## SERVICE BULLETIN

ENGINE - HP COMPRESSOR - INTRODUCTION OF WEIGHT REDUCED BOROSCOPE BLANKS - CATEGORY  
CODE 7 - MOD.ENG-72-0005

V2500-ENG-72-0005

Location of boroscope blanks  
Fig.1

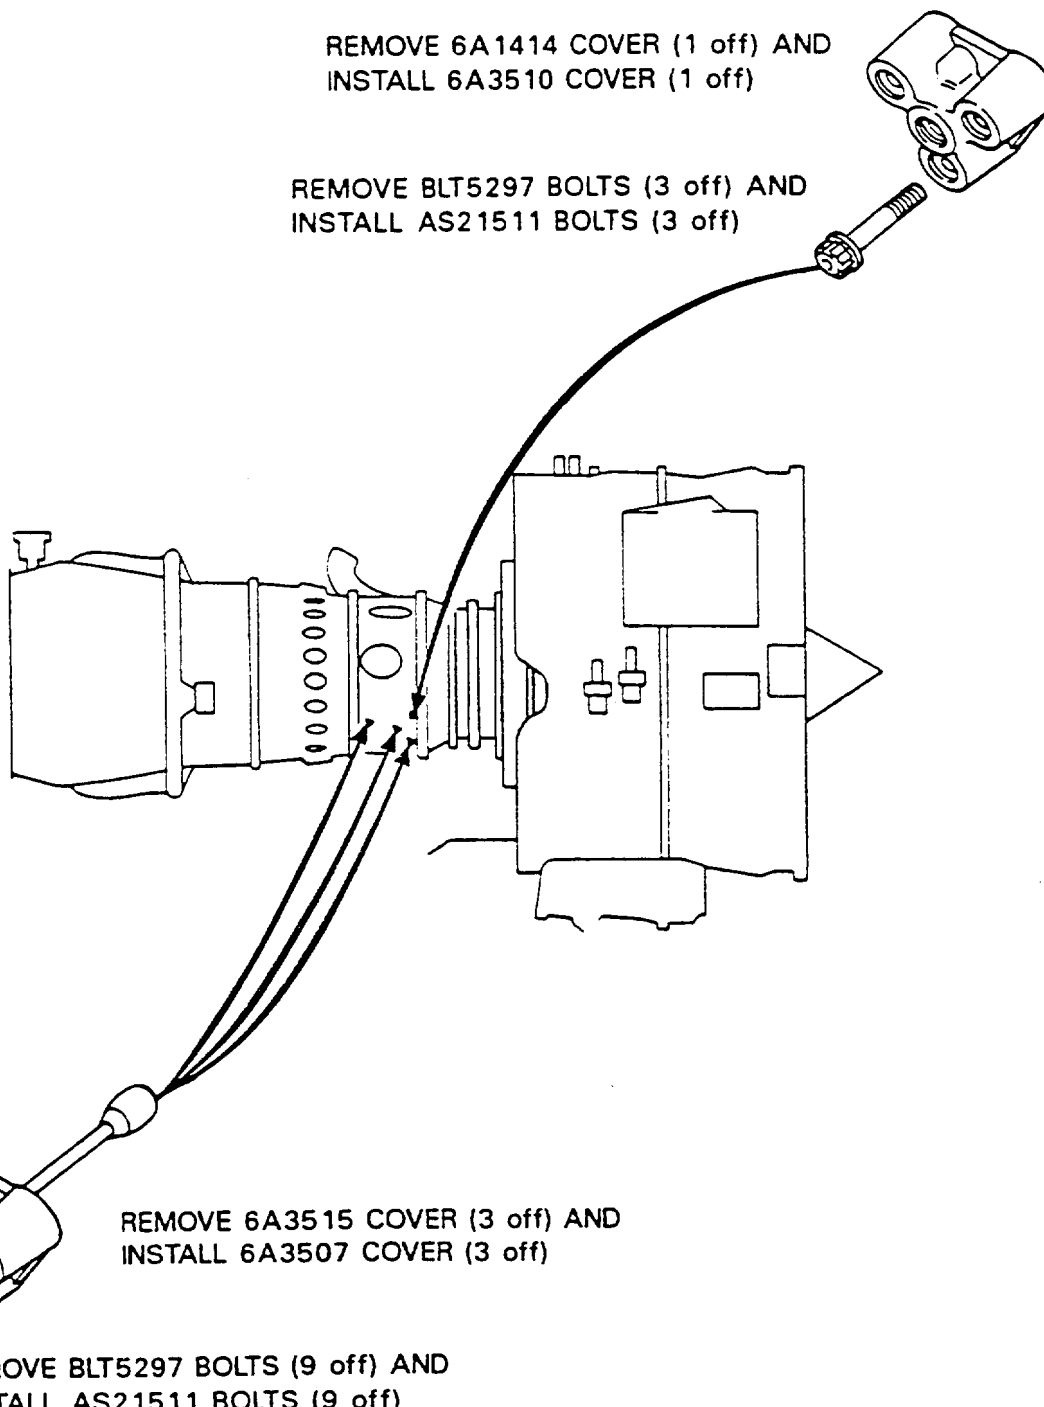
REMOVE 6A1414 COVER (1 off) AND  
INSTALL 6A3510 COVER (1 off)

REMOVE BLT5297 BOLTS (3 off) AND  
INSTALL AS21511 BOLTS (3 off)

REMOVE 6A3515 COVER (3 off) AND  
INSTALL 6A3507 COVER (3 off)

REMOVE BLT5297 BOLTS (9 off) AND  
INSTALL AS21511 BOLTS (9 off)
